Before the
FEDERAL COMMUNICATIONS COMMISSION
Washington, D.C. 20554

ET Docket No. 96-102
RM-8648
RM-8653

**WIRELESS INFORMATION NETWORKS FORUM
REPLY TO COMMENTS ON PETITIONS FOR RECONSIDERATION**

Figure 1: Antenna geometry and spherical coordinates²

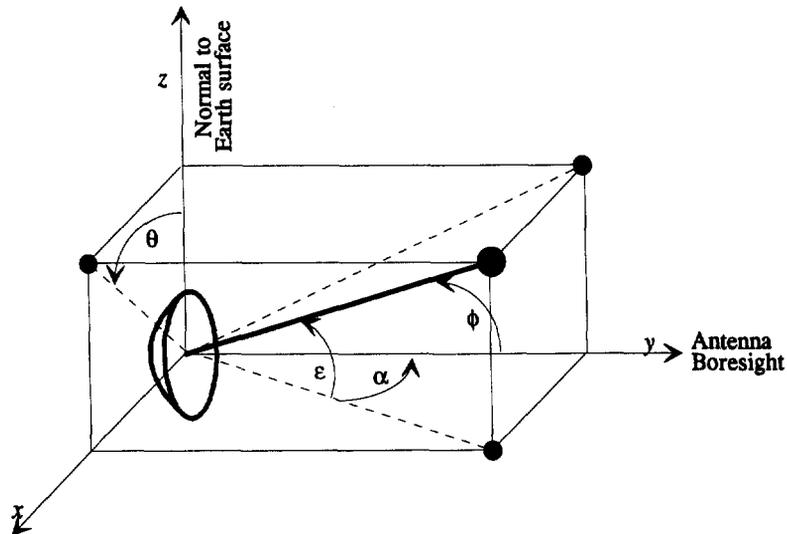
Based on this antenna model, AirTouch concluded that the average antenna gain would be about 2 dBi at maximum, with that maximum occurring at a beamwidth of about 60°.

MSS interests still seem to base their calculations and expectations of interference on that result. In fact, Exhibit 1 of the January 2 MSS letter states that "Globalstar considers the true average gain of the population of WDN [Wideband Data Network] devices, including those using antennas with gains greater than 6 dBi, to be between 1 and 2 dBi." Unfortunately, no technical data or analysis is provided by the MSS interests to support this view. Moreover, it seems to ignore the fact that on December 6, 1996, WINForum filed an *ex parte* letter with two detailed technical attachments providing extensive analysis of the average antenna gain of the unlicensed devices, as seen by the satellite.

where B_e is in radians. The AirTouch formula therefore has an excess gain (i.e., creates energy) that ranges from about 4.4 dB for small elevation beamwidths to about 3.8 dB for a 60° beamwidth. An energy-conserving antenna gain formula with the same relative gain as the AirTouch formula would be obtained by dividing the original AirTouch formula (4) by (6), so that (5) is satisfied.

Clearly, the AirTouch result for the average antenna gain is in error, because it is based on an antenna pattern that violates the laws of physics. The attachments to the December 6 WINForum letter provided analyses of average antenna gain for several different antenna types (including the corrected AirTouch antenna), and different distributions of unlicensed devices over the Earth's surface. It was concluded that the average gain is less than 0 dBi for antennas with any significant directivity, and that it is the actual transmit power (input to the antenna terminals) that determines the interference received by the satellite, not the average EIRP. It is important to note that these analyses did not assume any power backoff for high-gain antennas. Given the backoff required by the FCC rules for gains exceeding 6 dBi, use of a 0 dBi average antenna gain is conservative (may overestimate the actual interference).
